CITY OF MILWAUKIE

PLANNING COMMISSION MINUTES

April 12, 2022

5.1 9285 SE 58th Dr

SHEET:
A-2

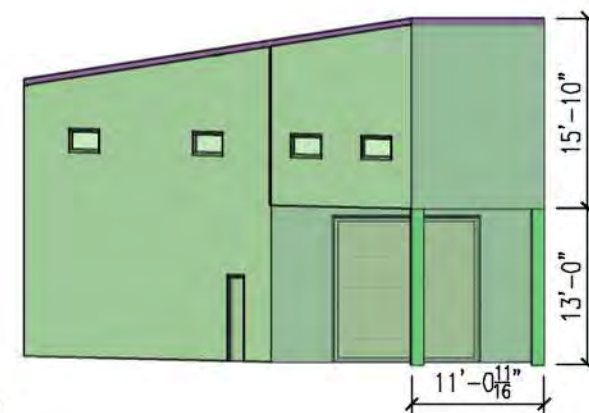
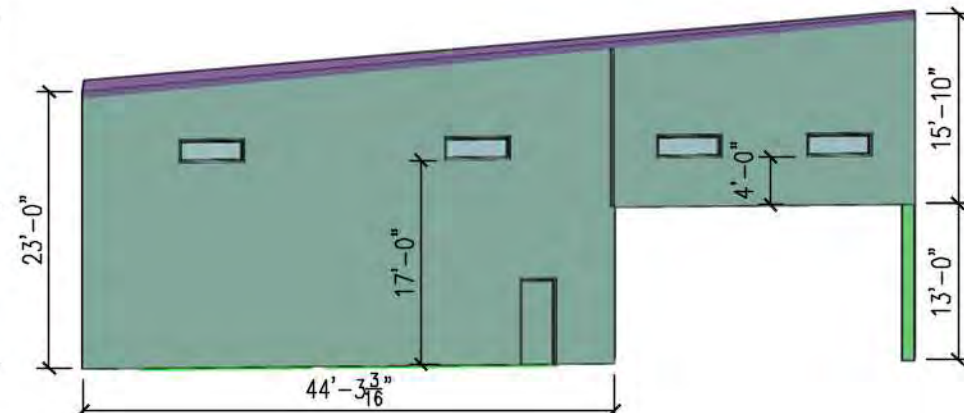
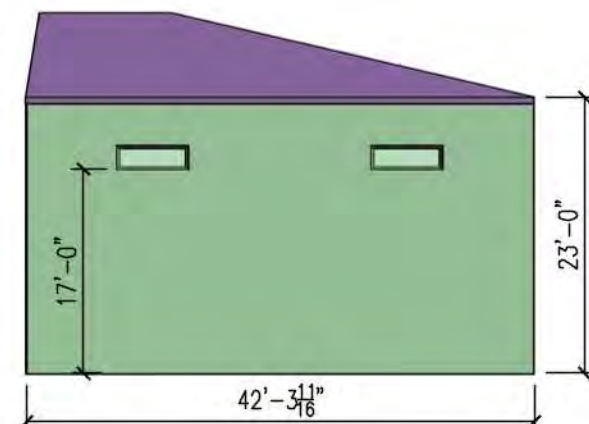
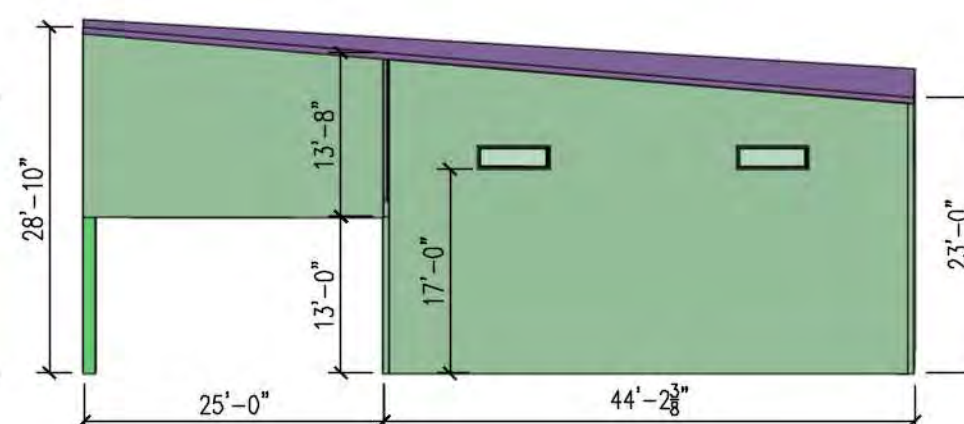
Response ➡ This proposal stays within the maximum height of 45' with a northern roof height of 28'-10", sloping to a southern roof height of 23'-0". Refer to sheet A-2 of "3b - Proposed Building Plans.pdf" for elevations.

C-1

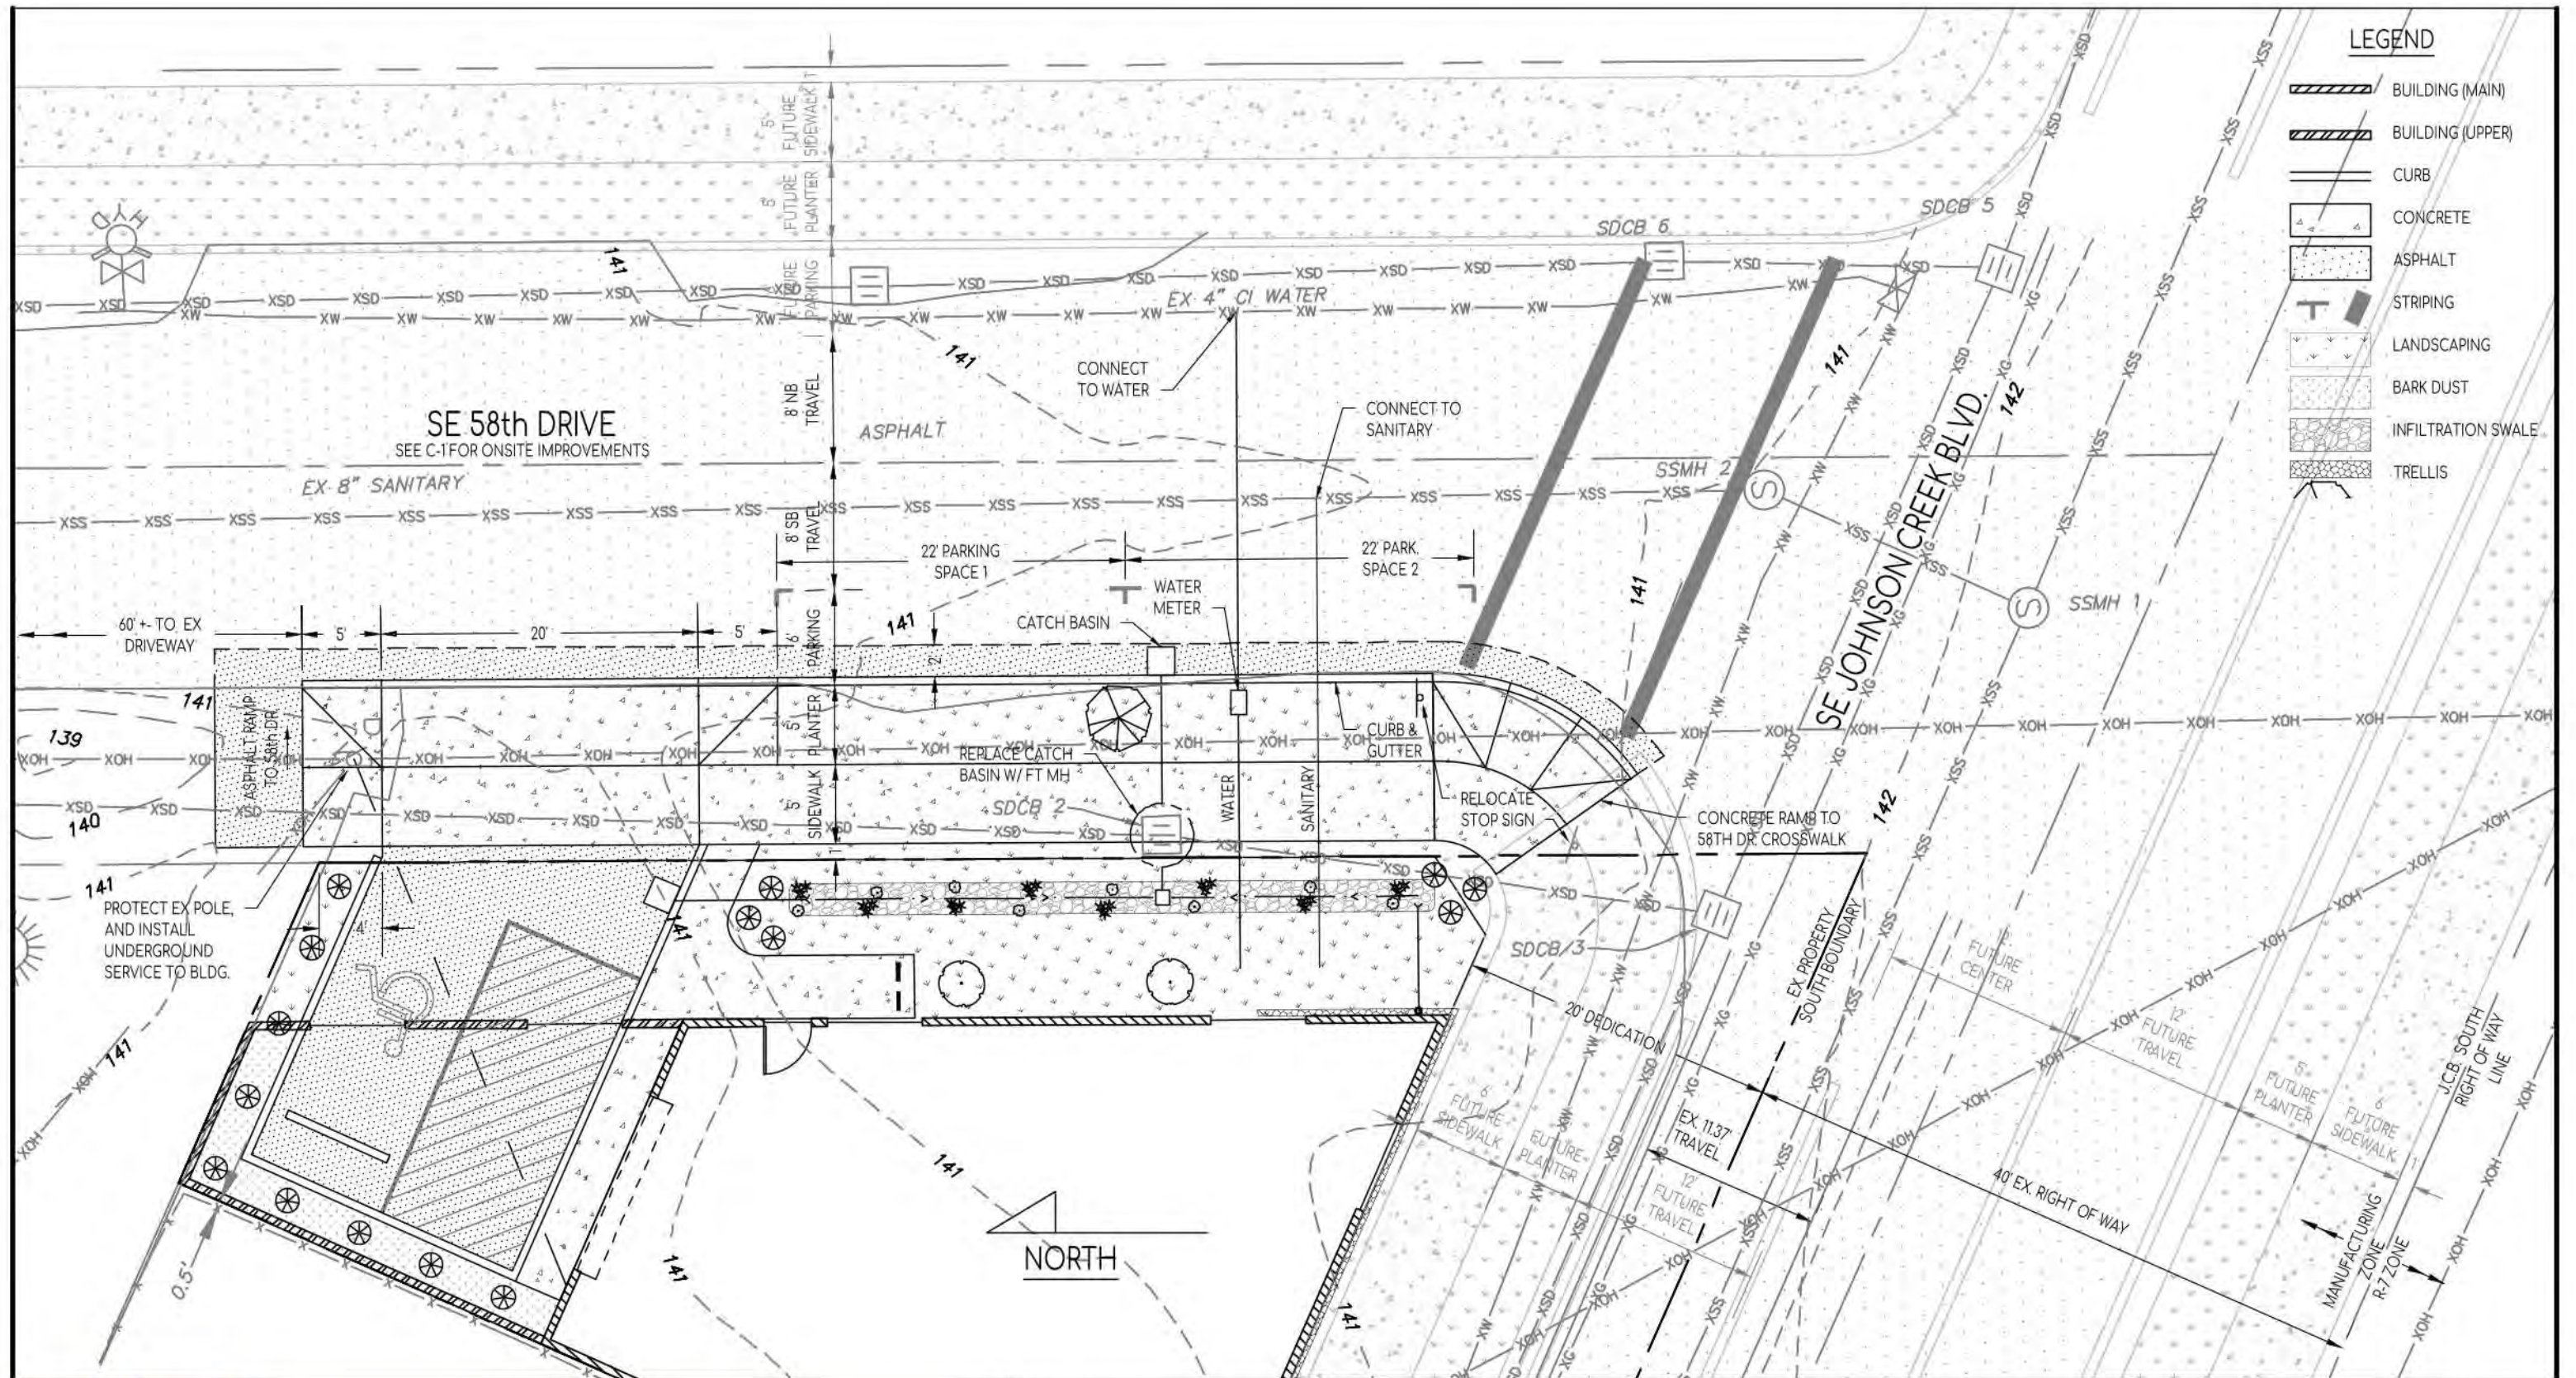
Response ➡ While front setback std is 20' the proposed site improvements include a building line with Zero lotline setback due to the required right of way dedication of 20'. This triggers a Type III variance and is discussed under section MMC19.911.4.B below. Corner side yard setbacks of 10' are supplied between the building and SE 58th Drive. No rear or side setbacks are required or provided. Refer to sheet C-1 in "5b - Proposed Site Plans.pdf".

Response ➡ This proposal meets the 15% minimum landscaping requirement. Plan set sheet C-1 in "5b - Proposed Site Plans.pdf" shows lot coverage and vegetation calculations of 547 sf landscaping proposed. Of that, 333 sf will be planted with ground cover, 99 sf will be covered in bark, and 80sf of planted stormwater swale. The bark chip area is only 18% of total landscaping proposed, staying well under the required 20% maximum. The street frontage includes one proposed street tree meeting the requirement of 1 per 40 LF of planter. Plan set sheet C-1 illustrates planting location and types. The specific variety of trees, shrubbery, and various ground cover will be specified in development plans.

Due to site constraints, this proposal requests a variance for the reduction in the required minimum width of perimeter landscaping area from 6ft to 3ft. The Type III Variance Approval Criteria for Parking Perimeter Landscaping is itemized near the end of this detailed statement under MMC19.911.4.B. This northern planter area shall be covered in bark and planted with shrubs. Please refer to the attached "4b - Access Study.pdf" which limits site distance if a tree were planted in the aforementioned landscaping buffer area. No tree is proposed here, please refer to sheet C-1 of "5b - Proposed Site Plans.pdf".

SHEET TITLE: PROPOSED PUBLIC ROAD IMPROVEMENTS

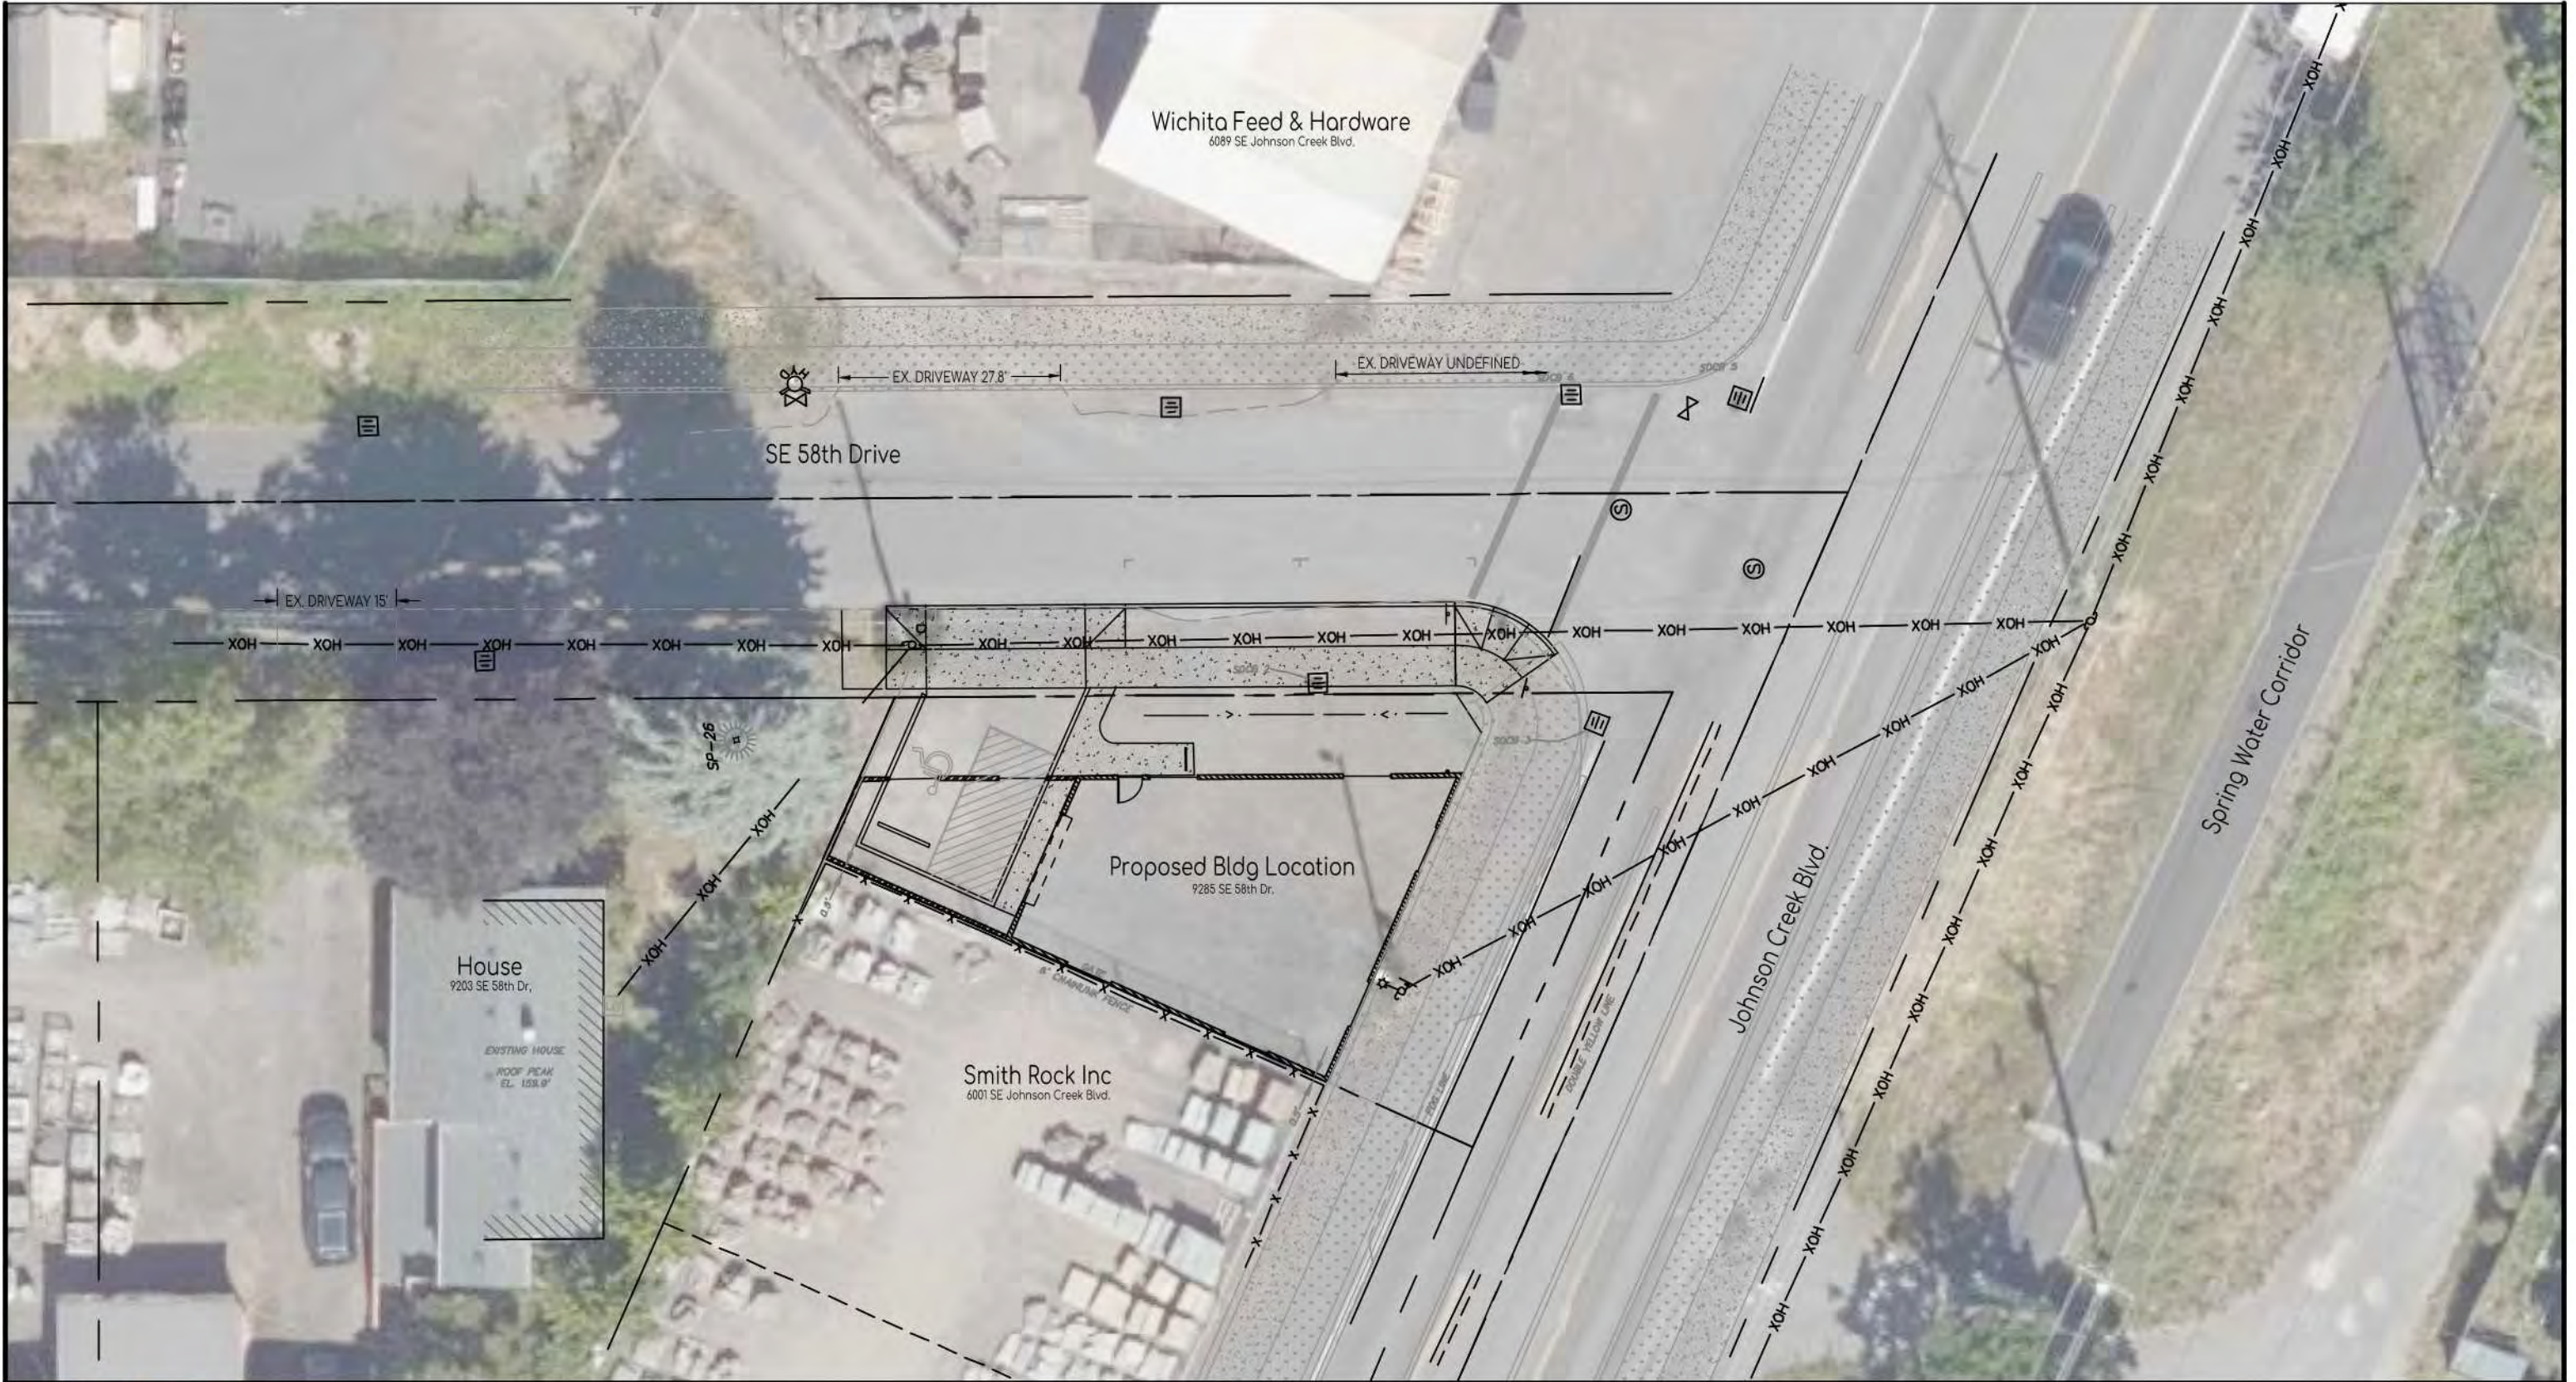
1 & 2 = SE 58th Drive shall include a local half street improvement in accordance with MMC19.700 and Public Works standards. The proposed development impacts will not require construction of frontage improvements along Johnson Creek Boulevard. Refer to sheet C-2 of "5b - Proposed Site Plans.pdf".

Address: 9285 SE 58th Dr

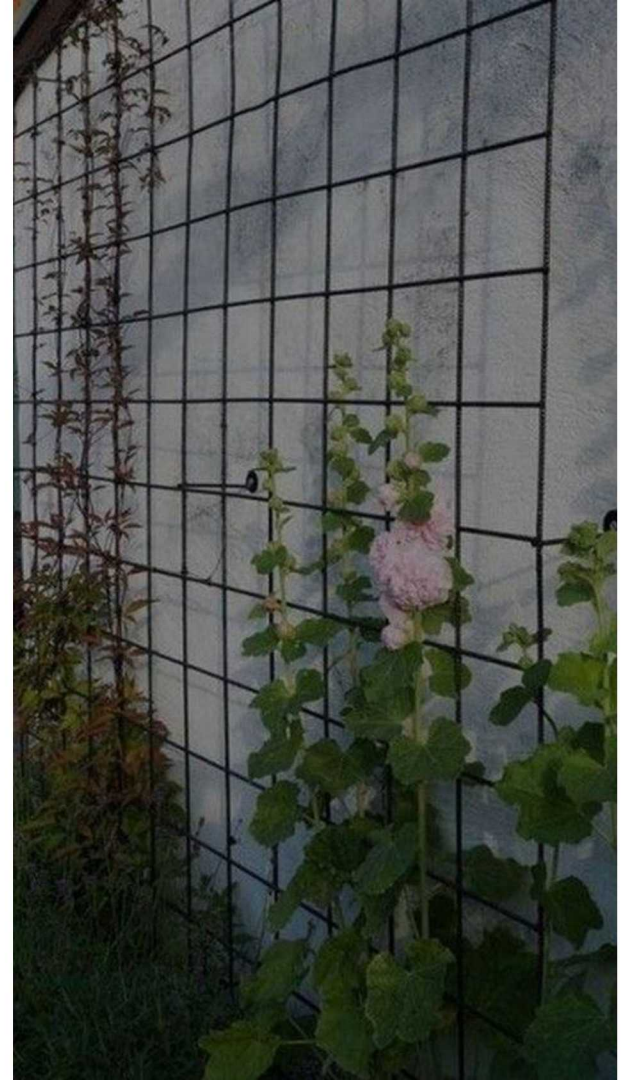
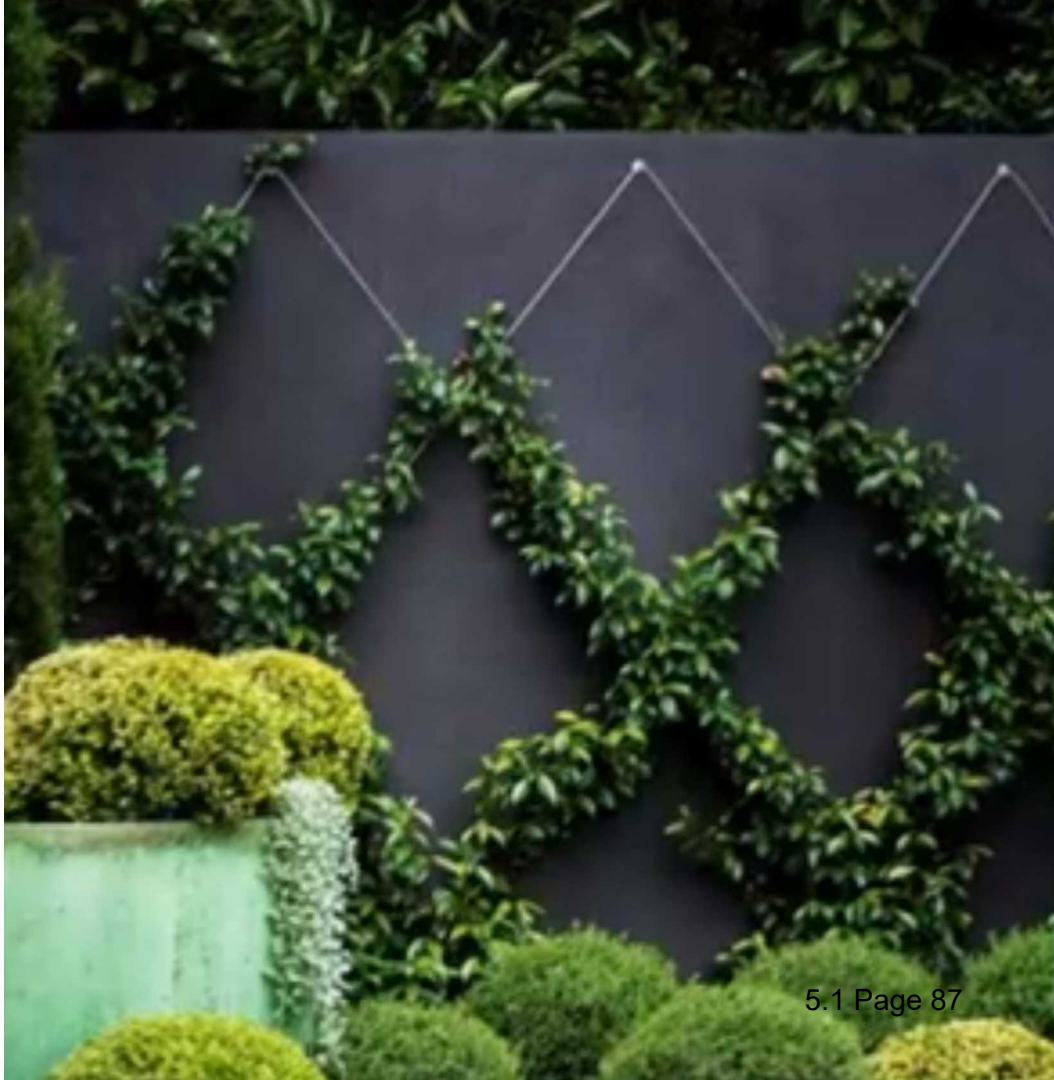
The Applicant Team shared their presentation which showed the proposed site plans and building design. There is 6 inches of separation between the building and Right of Way (ROW) to account for the screened wall feature. The Applicant Team plans on adding a trellis to the wall with vegetation, but other screening options are being considered. Other options include decorative fencing, a wire trellis, or hanging vegetation.

5.2 SB 458 Code Amendments
